Staff Report
 PZ20-00007 (SUB)
 The Refuge Subdivision
 Summary Sheet

Meeting Date: October 18, 2022
Hearing Body: Planning and Zoning Commission
Project Summary: **11 unit single family house subdivision**
Action Requested: Recommendation of Approval of Preliminary Plat
Staff Recommendation: Recommendation of Approval, with conditions, of Preliminary Plat
Location: 165 Golden Eagle Drive
Parcel Number: 408-10-060B & C
Owner/Applicant: Simno Holdings LLC (Chris Tortorello)
 PO Box 4449; Sedona, AZ 86340
Authorized Agent: SEC, Inc. (Krishan Ginige)
 825 Cove Parkway; Cottonwood, AZ 86326
Site Size: ± 6.47 acres
Community Plan Designation: Single Family Low Density
Zoning: RS-18 (Single-Family Residential), maximum density: 2 units per acre
Current Land Use: Vacant
Surrounding Properties:

PRELIMINARY PLAT
THE REFUGE AT SEDONA
A PORTION OF THE NORTHWEST 1/4 OF SECTION 14, T.17N.,
R.5E., G. & S.R.M., YAVAPAI COUNTY, ARIZONA
ASSESSOR PARCELS 408-10-060B AND 408-10-060C
CITY OF SEDONA
±6.46 ACRES
APPLICATION NO. PZ20-00007 (SUB)

EXHIBIT CONCEPTUAL WALKING TRAIL PRELIMINARY PLAT THE REFUGE AT SEDONA

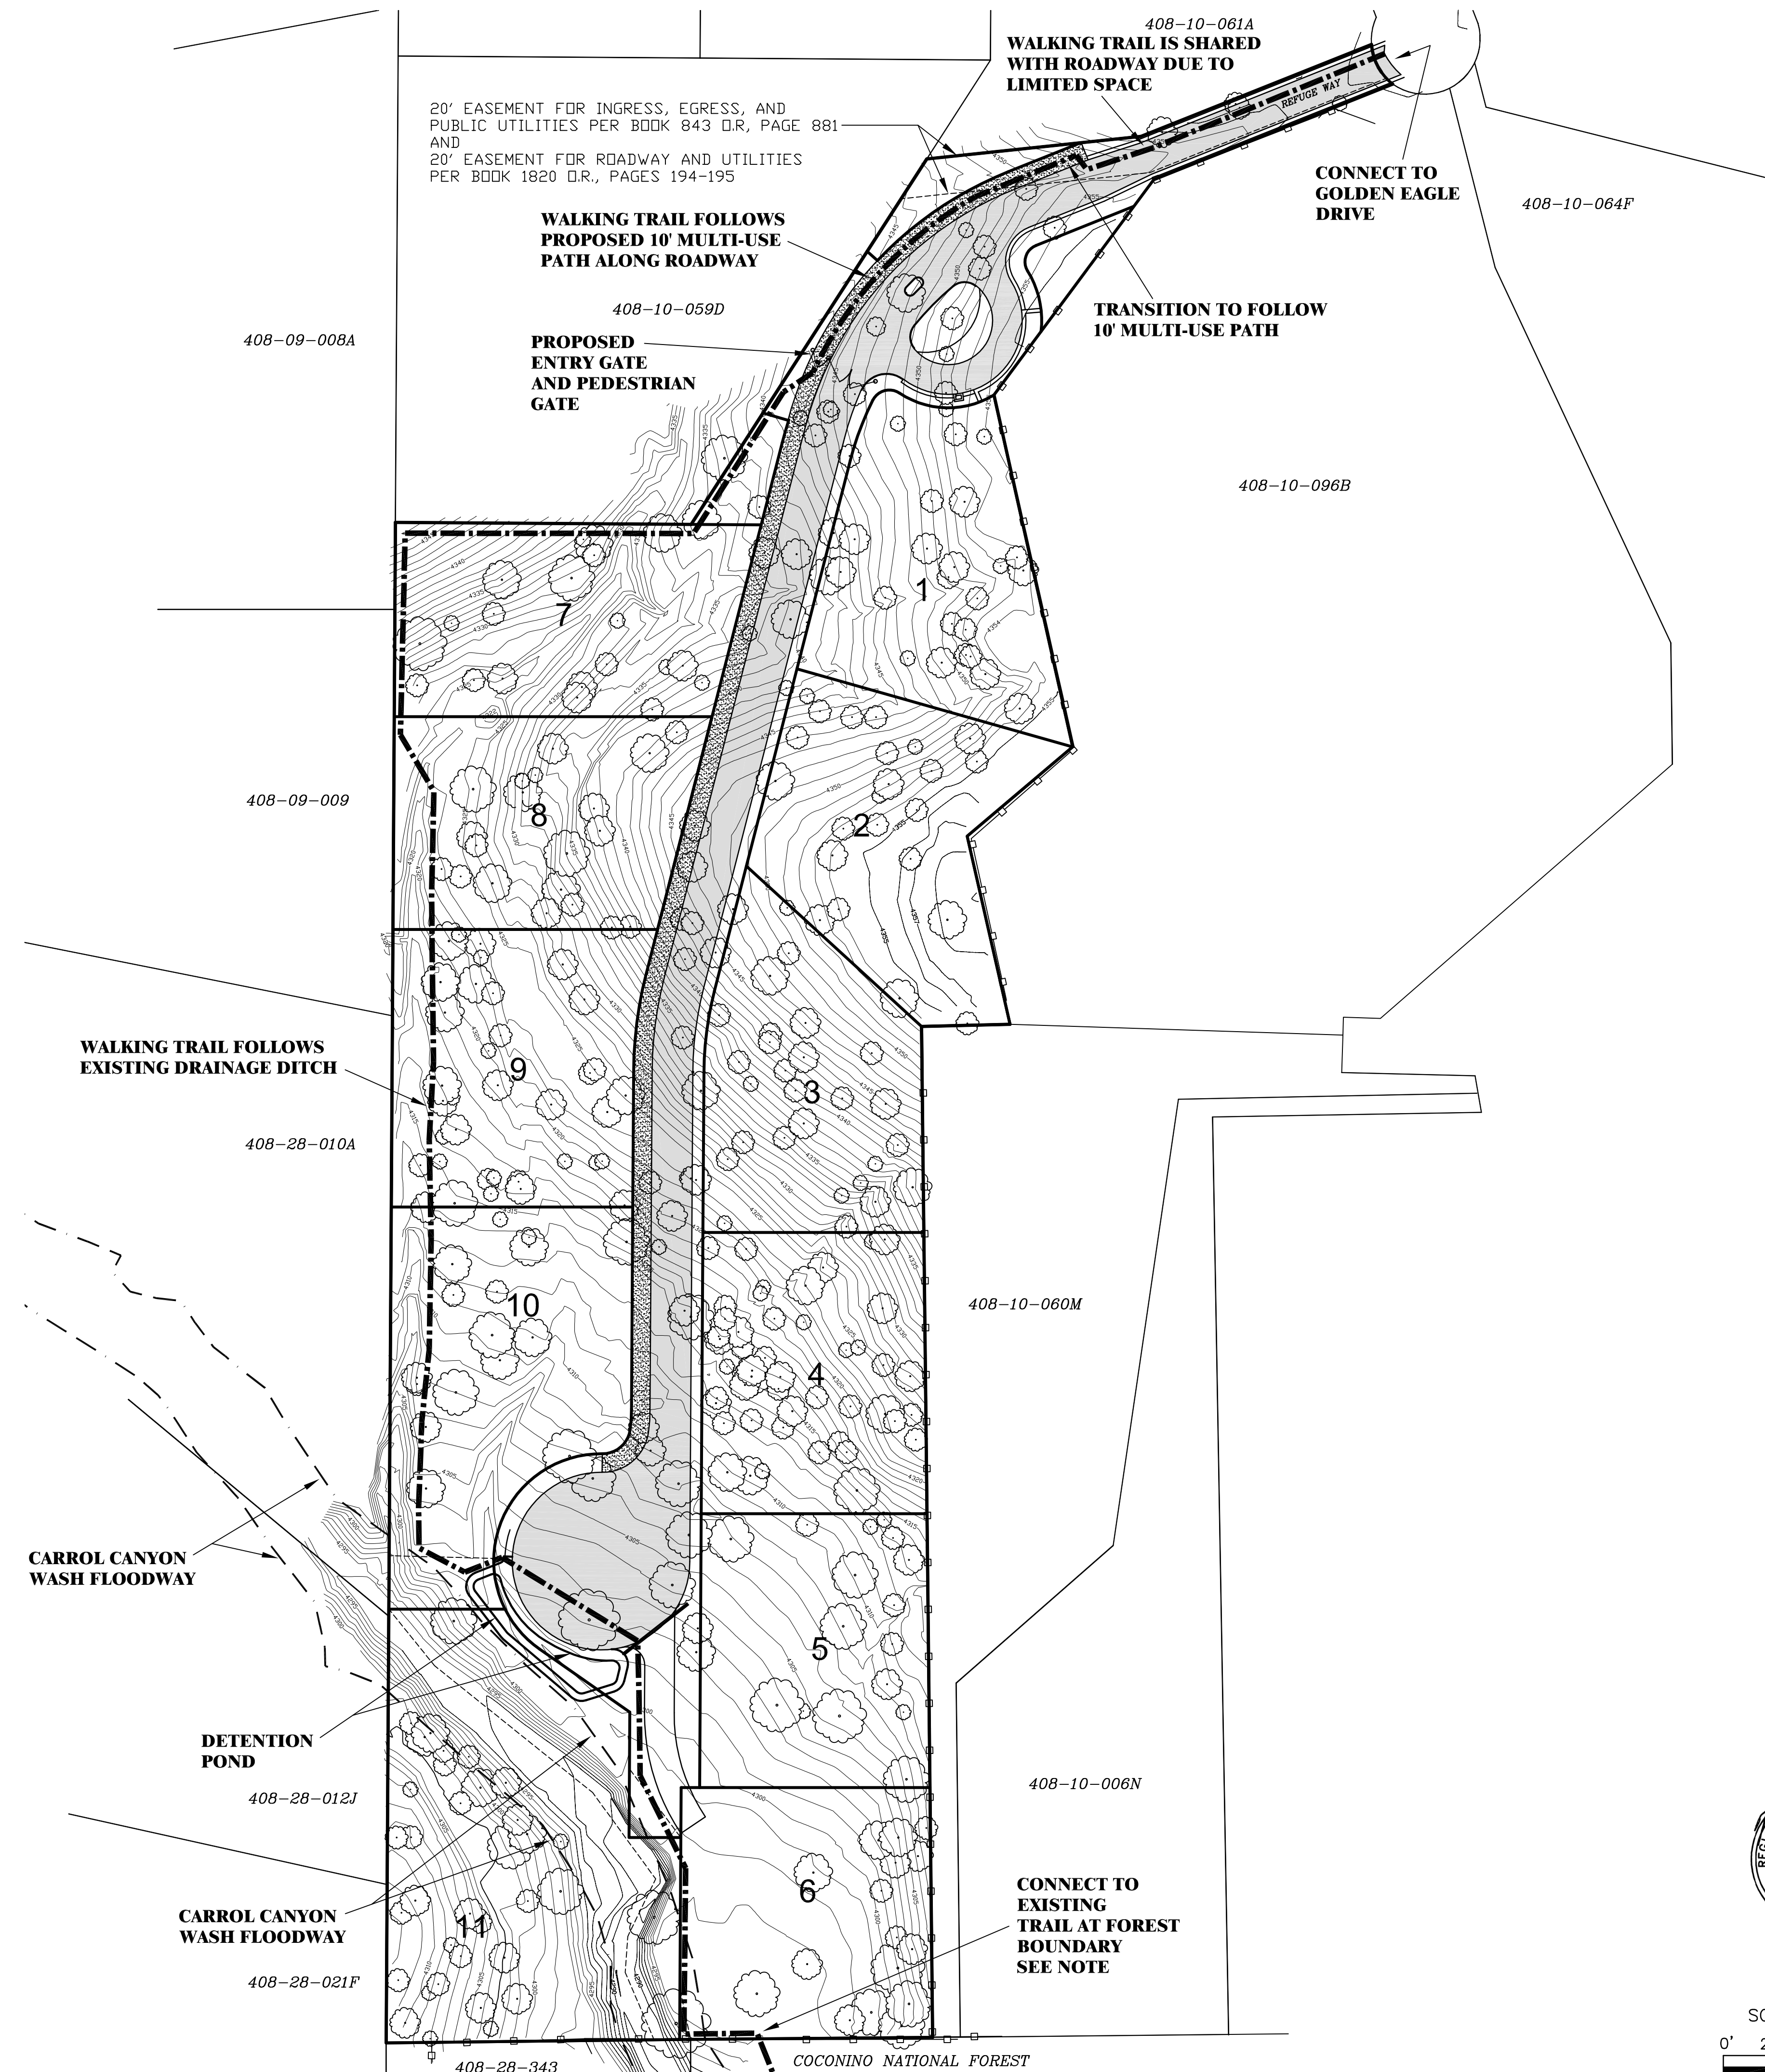
I can see the plat includes what is shown as a pedestrian access trail through the property. I am relieved. I would add that this access trail should remain and become a requirement for this development AND that it be sufficient to allow multiple users including bikes and pet . If a sufficient trail is included i would not object personally to this development . However. At the same time my feeling is that larger lots, of .50 acres minimum and closer to .75 acres would be more consistent with the immediate neighbors. Thank you for the opportunity to comment.

- ii) The Final Plat shall show a precise location and width for the pedestrian access, connecting Golden Eagle Drive to the Coconino National Forest Boundary, and appropriate dedication language.

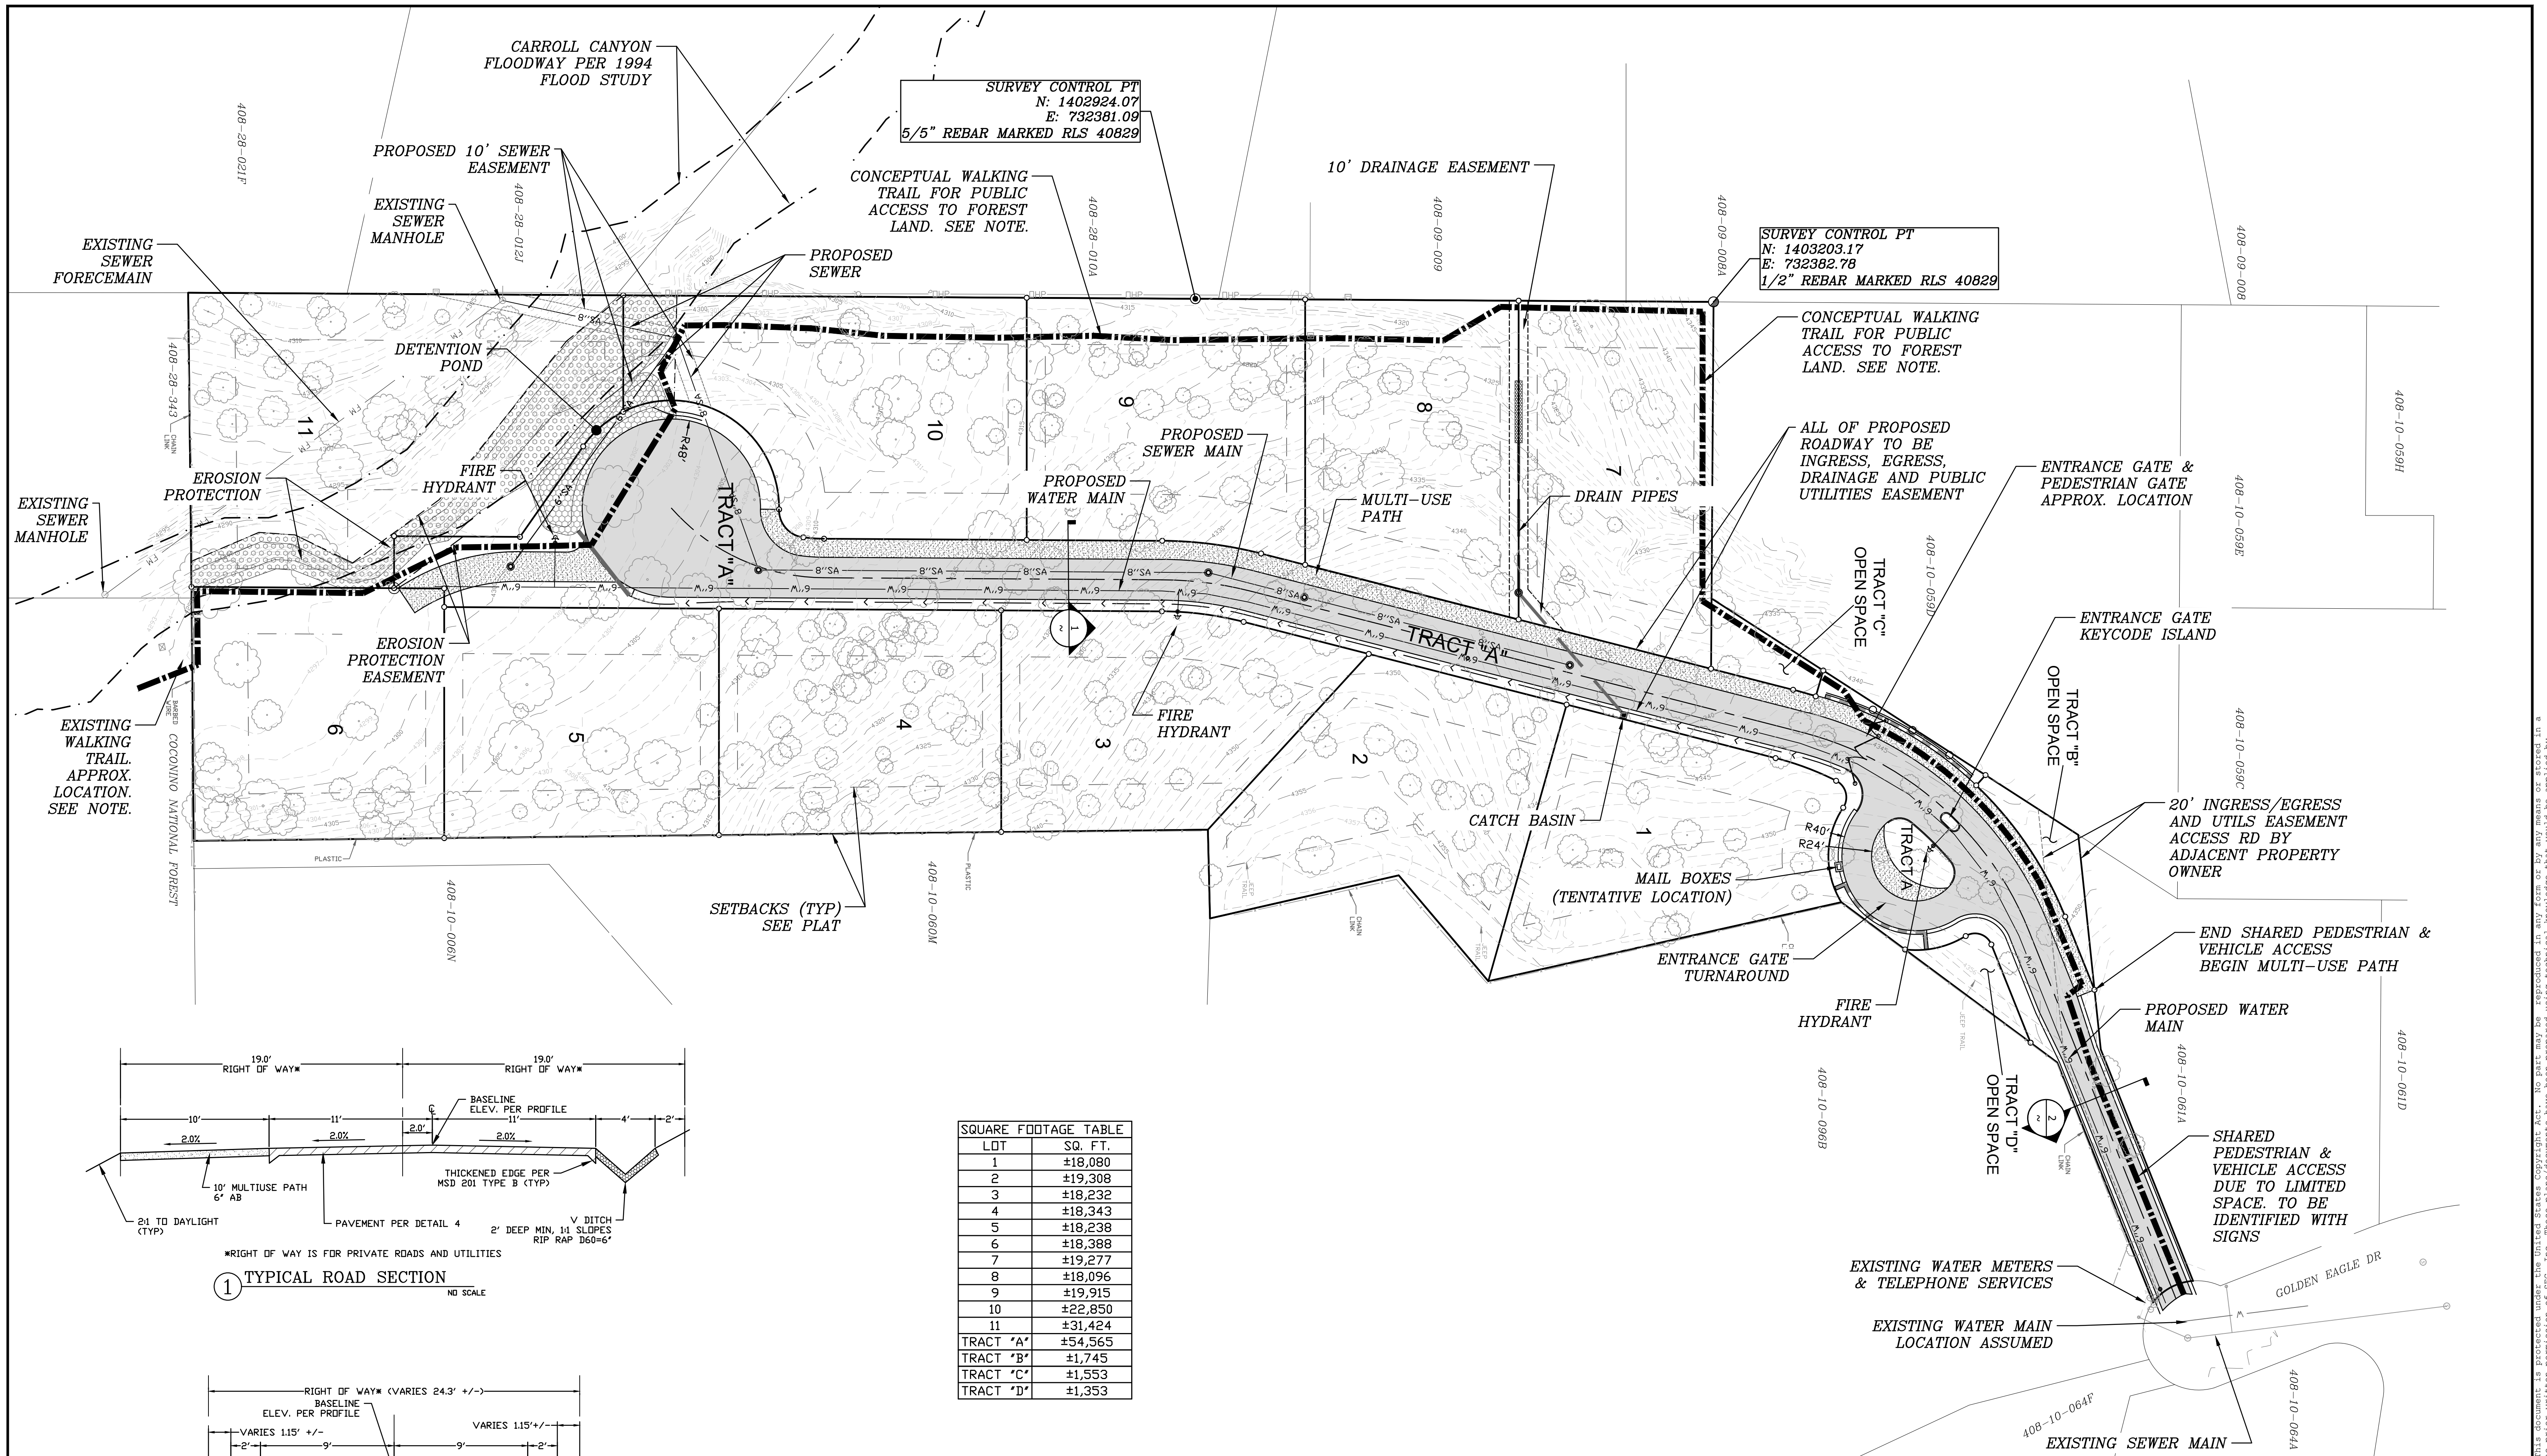
The Setbacks depicted on the site plan do not meet RS-18 Code or even RS-10 code. Of particular concern to the homeowners of Thunderbird Hills South Unit 2 is the 10-foot setback along the eastern side of the property which abuts Thunderbird Hills South Unit 2 lots. The standard rear setback for RS-18 is 25 feet. The 10-foot setback proposed not only does not meet the RS-18 standard or the RS-10 standard. The remaining setbacks also do not meet the RS-18 standard. As far as we have been able to tell, the RS-18 setback standard would still apply to a Cluster Subdivision. The only individual lot standard (minimum) for a Cluster subdivision is a lot width of 25 Feet (Article 2.J.2.C of LDC); otherwise the Cluster standard refers to the basic RS-18 code.

① TYPICAL ROAD SECTION
 NO SCALE

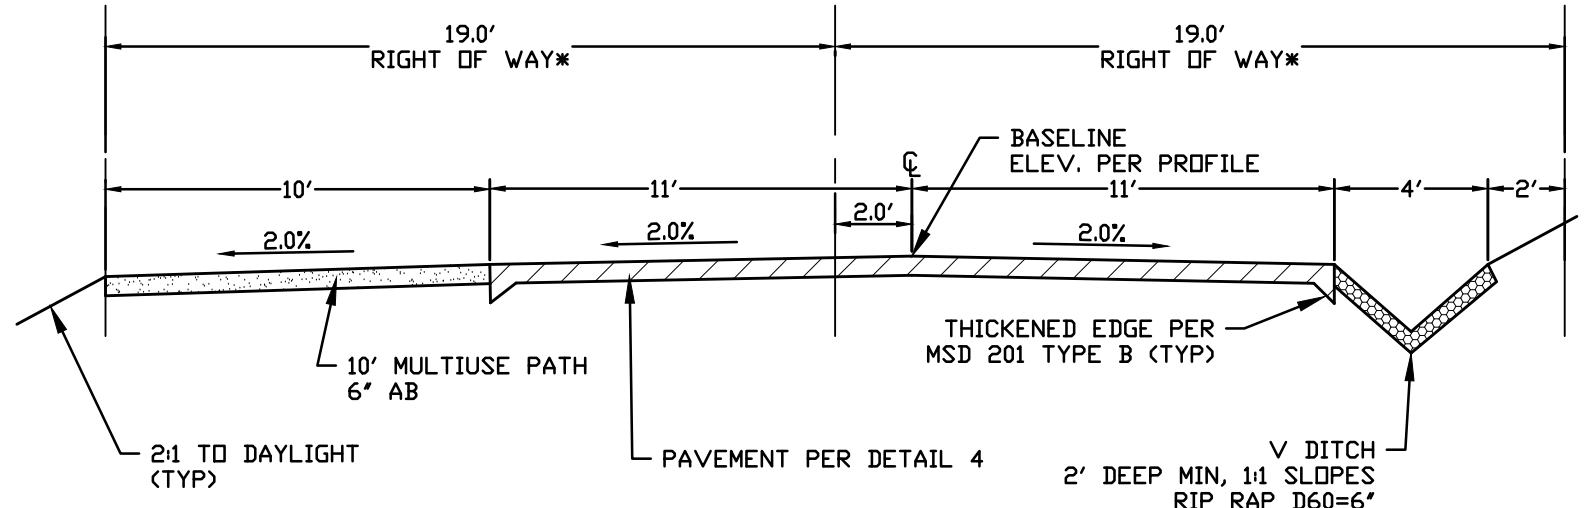
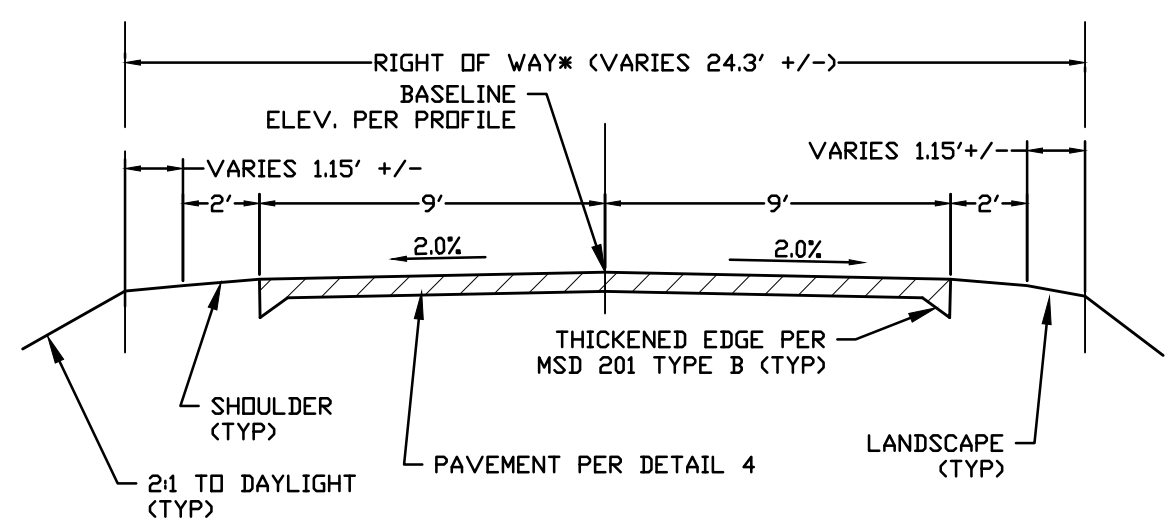
- The GO! Sedona Plan includes a trail connection through this property, which is included as part of the plat.
- The streets have been designed to meet the minimum requirements, with the exception of the first 150 feet of the proposed street.
